Re: Albion Park Quarry – Stage 7 (SSD-10369) RFI - 11 November 2022

I refer to the Department's Request for Information RFI 2 dated 11 November 2022 in relation to further visibility matters for the above proposed development. The following provides a response prepared by Cleary Bros and RWC to both matters raised. The additional information requested is highlighted in *italics* with the response in a normal font.

Plate A: A View to the West from Stage 6 towards the Holcim Albion Park Quarry

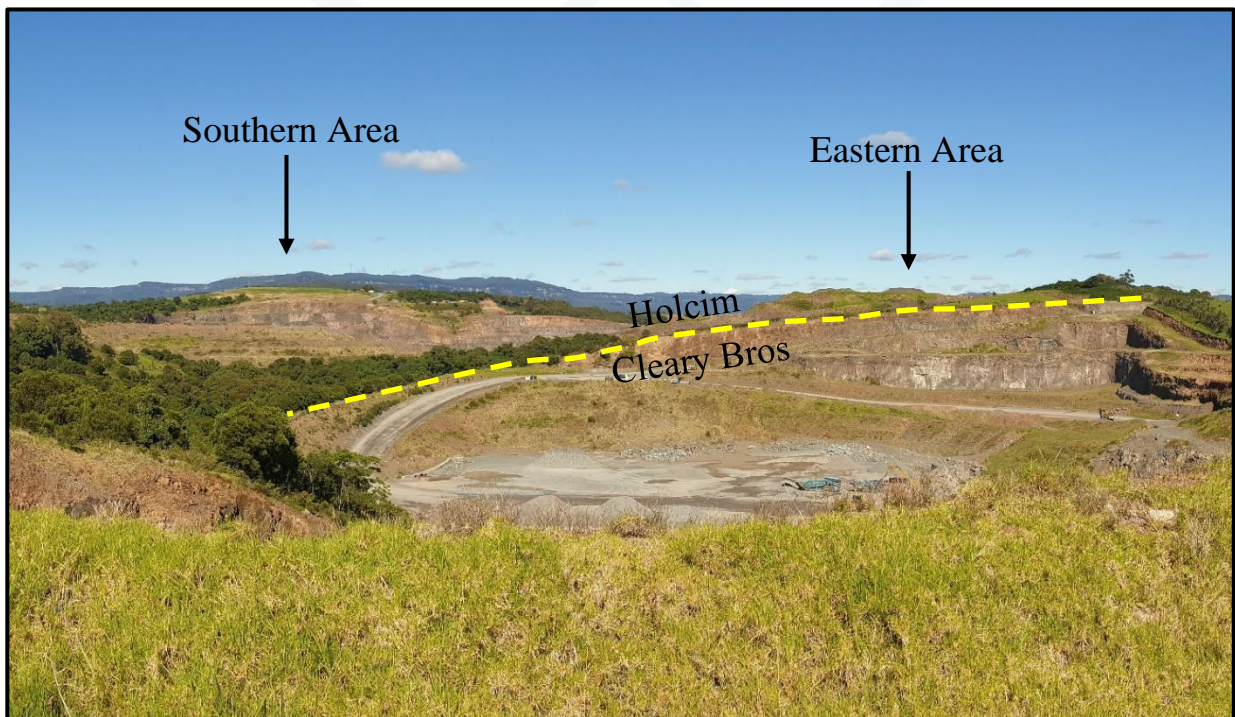
Plate A shows a recent photograph (captured 17 November 2022) from the eastern boundary of Stage 6 towards the elevated section of the revegetated overburden within the Eastern Area and the upper extraction faces within the Southern Area of Holcim’s Quarry.

Figure D
VIEW FROM SITE 3a -
EXISTING AND END OF STAGE 7e

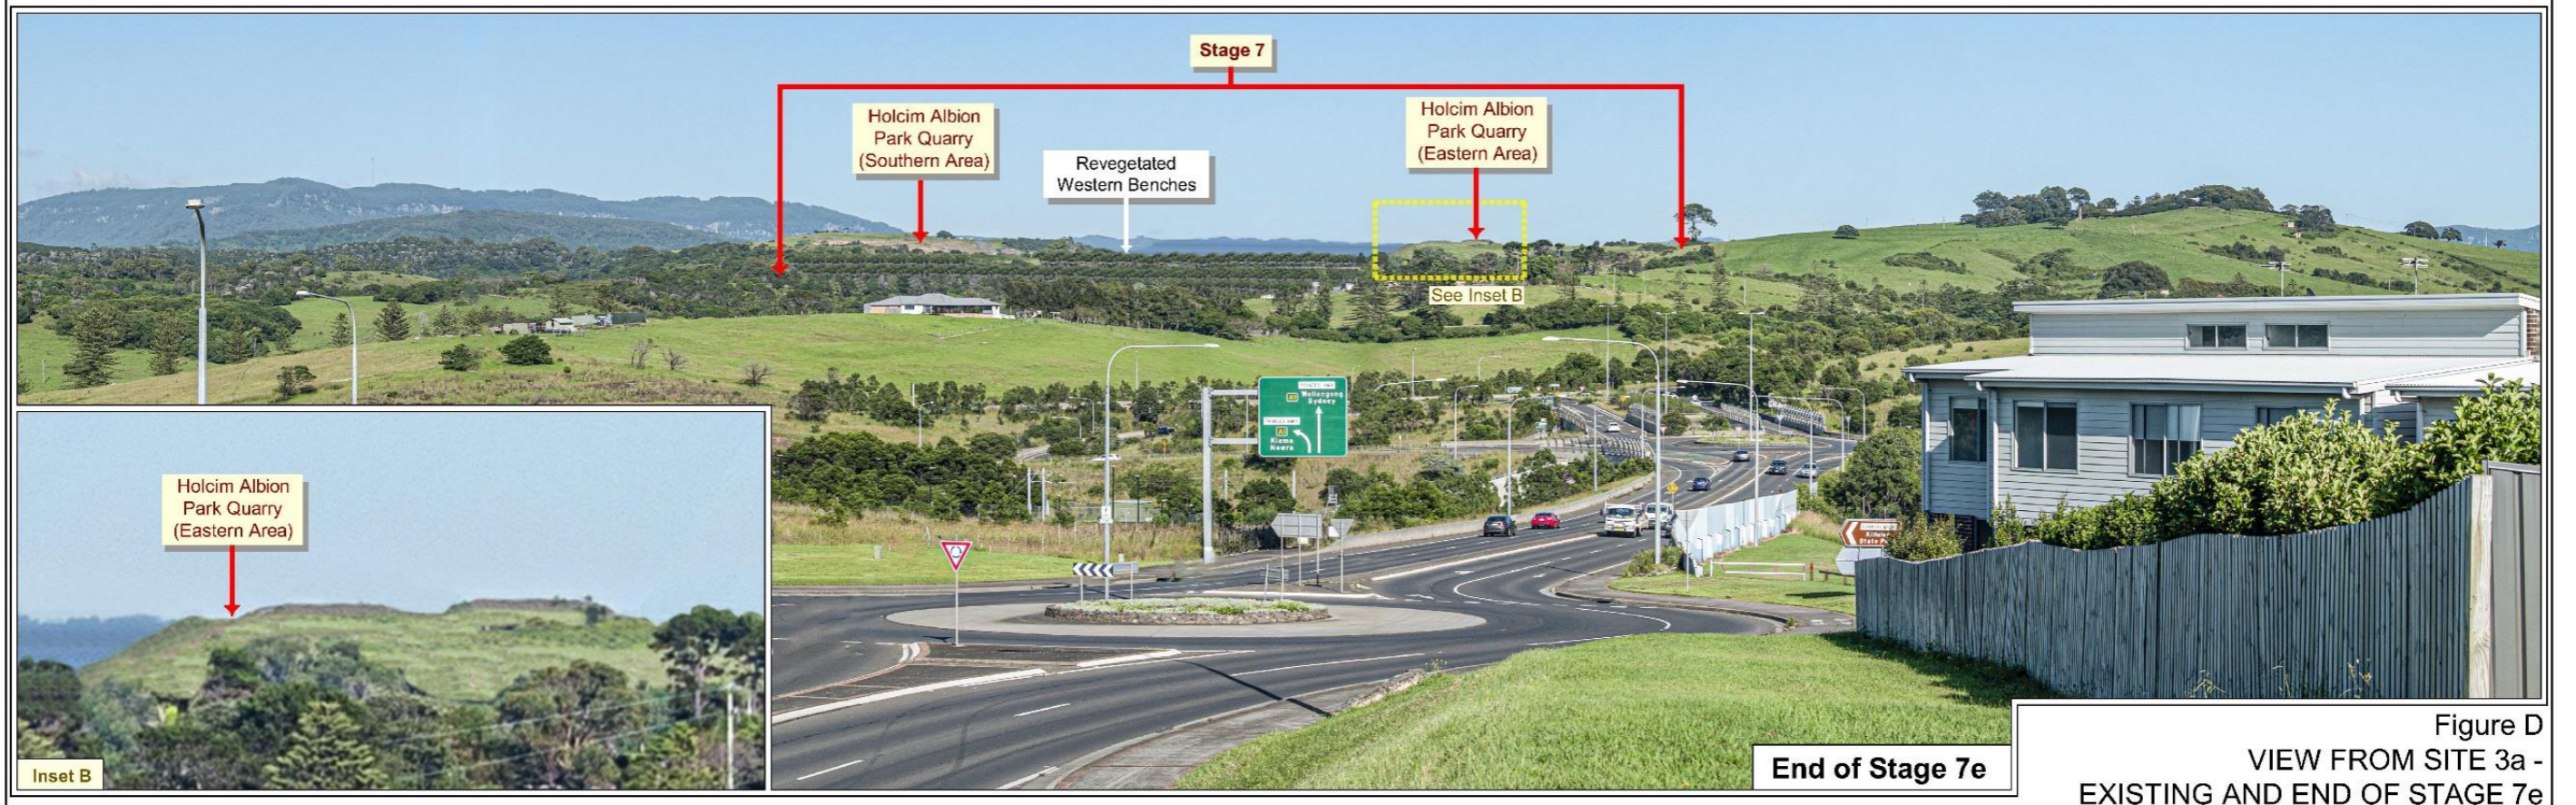
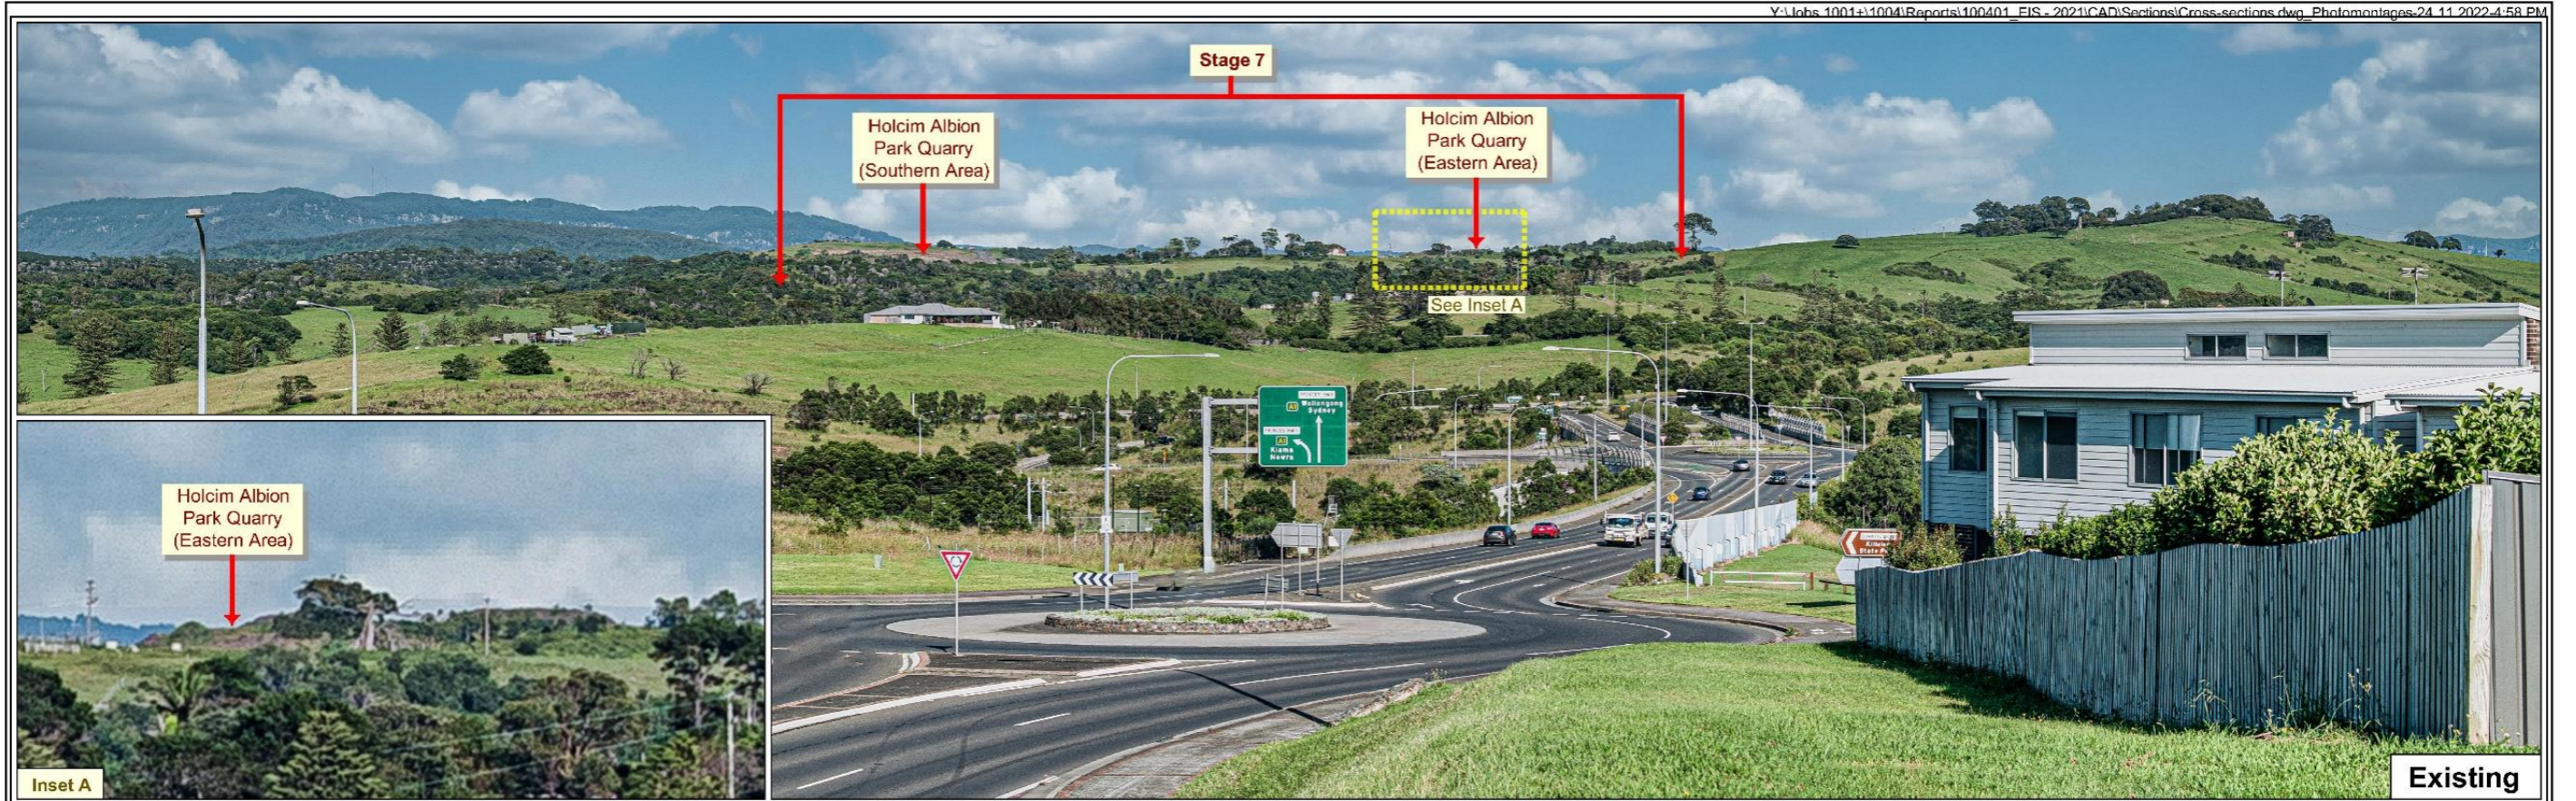
Submit a visual assessment that considers potential views of the Holcim Albion Park Quarry once the proposed Stage 7E is quarried. The assessment should consider the visual impact from multiple viewpoints both before and after the quarrying of proposed Stage 7E. The assessment must include:

- *map of viewpoints able to view the Holcim Quarry*
- *visual transects from at least two of those locations*
- *visual montage for the selected locations that demonstrates the appearance of the Holcim Quarry*
- *assessment of the impact of any views identified by the visual assessment*

Figure C displays the visual transect from Site 3a and the prepared cross-section which indicates that approximately 4m of the elevated section of the Eastern Area is just visible at present. Following the completion of extraction within Stage 7e, a further 8m (vertically) of the Eastern Area could be seen from Site 3a together with approximately 23m (vertically) of the rehabilitated sections of Stages 1 to 6 immediately in front of the Eastern Area. A photomontage from Site 3a (**Figure D**) displays both the existing view and the view after completion of extraction within Stage 7e, together with an enlarged inset of the visible component of the landform within the Eastern Area of Holcim's Quarry and the immediate foreground within Stages 1 to 6.

A comparison of the existing view from Site 3a towards the Southern Area within Holcim's Quarry and the view at the end of Stage 7e shows virtually no change to the views of the Southern Area. The existing vegetation immediately beyond the western boundary of Stage 7a that currently partly screens the elevated extraction benches in the Southern Area would be retained. Hence, there would be negligible change in the visibility of the Southern Area when viewed from Site 3a.

Figure 1
 SEEN AREA FROM "ST IVES" -
 2 JAMES ROAD AND VISUAL TRANSECT

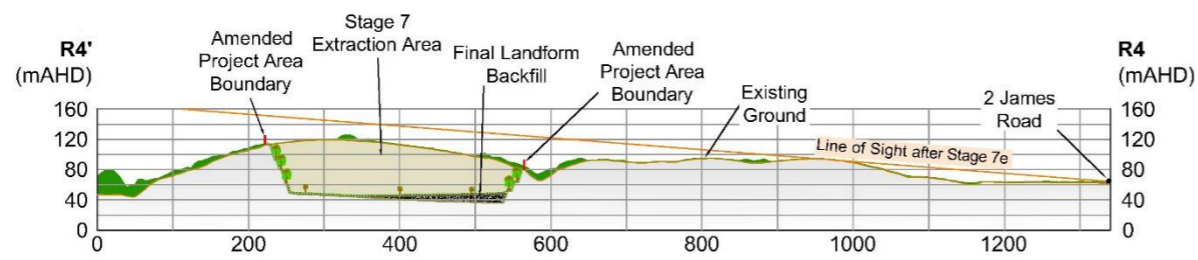
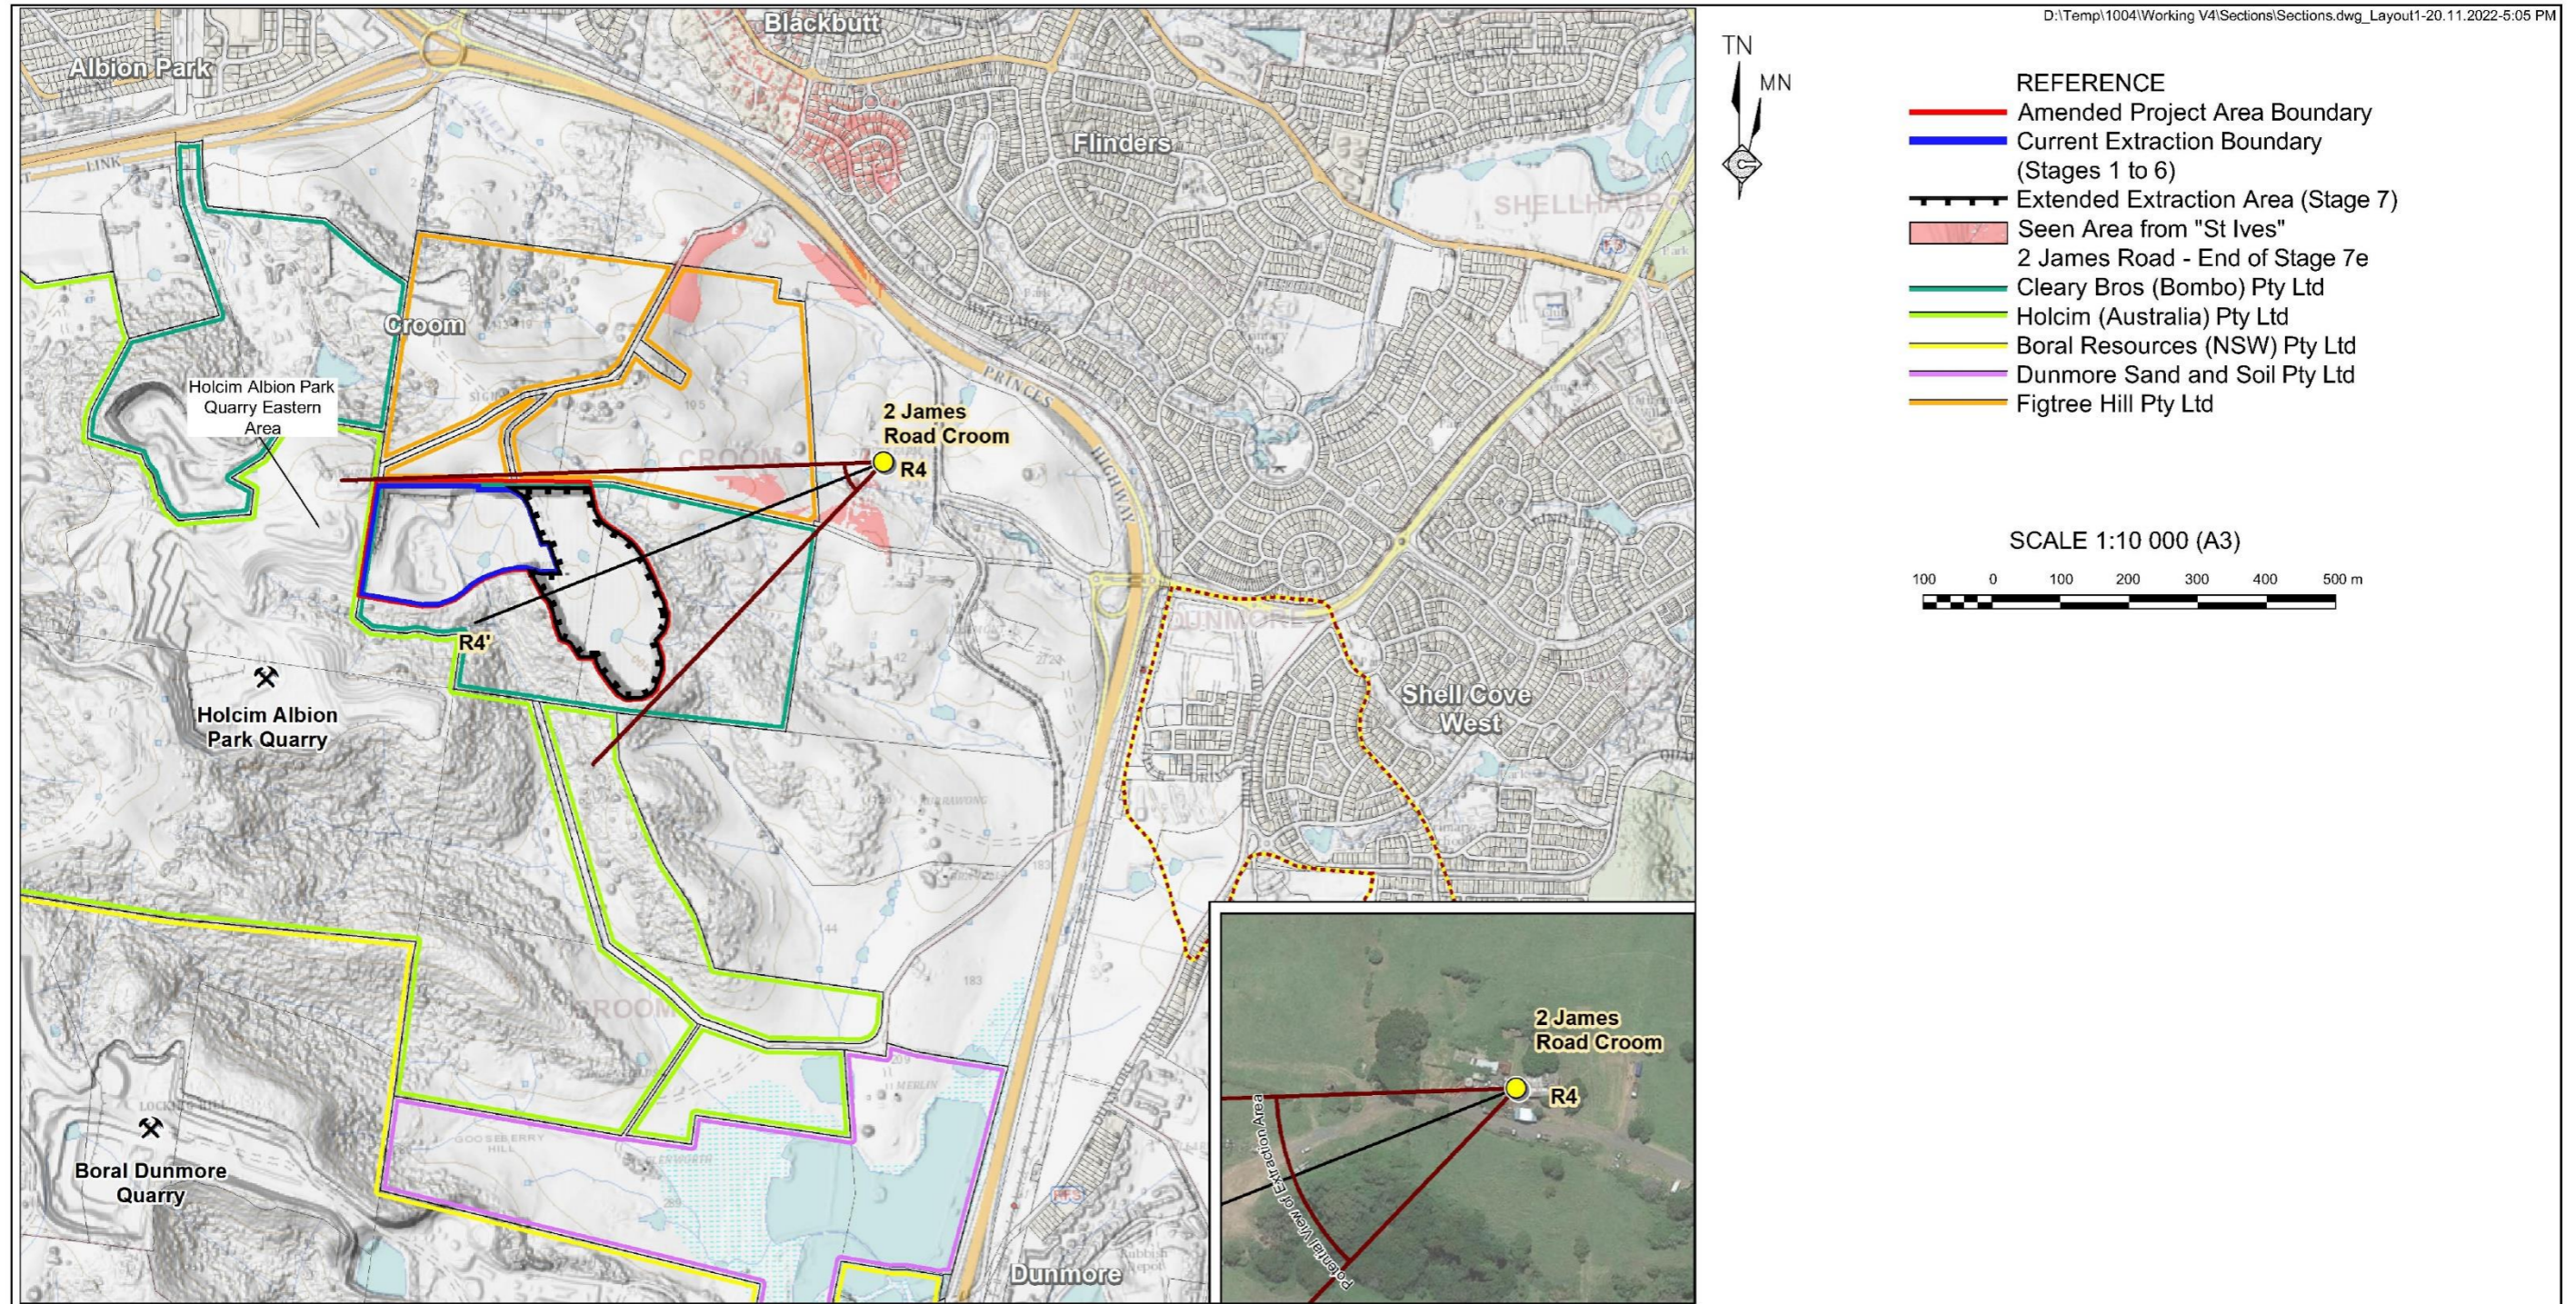
Submit a visual transects demonstrating the views from homesteads listed as heritage items under the Shellharbour Local Environmental Plan 2013, including:

- “St Ives” – 2 James Road Croom (Residence 4)
- “Rosemont” – 35 James Road Croom (Residence 9)
- “Kurrawong” – 126 James Road Croom (Residence 6)

- “St Ives”** The cross-section from “St Ives” shown on **Figure I** displays that the existing intervening topography between the residence and Stage 7 would prevent any views of the activities or final faces within Stage 7.
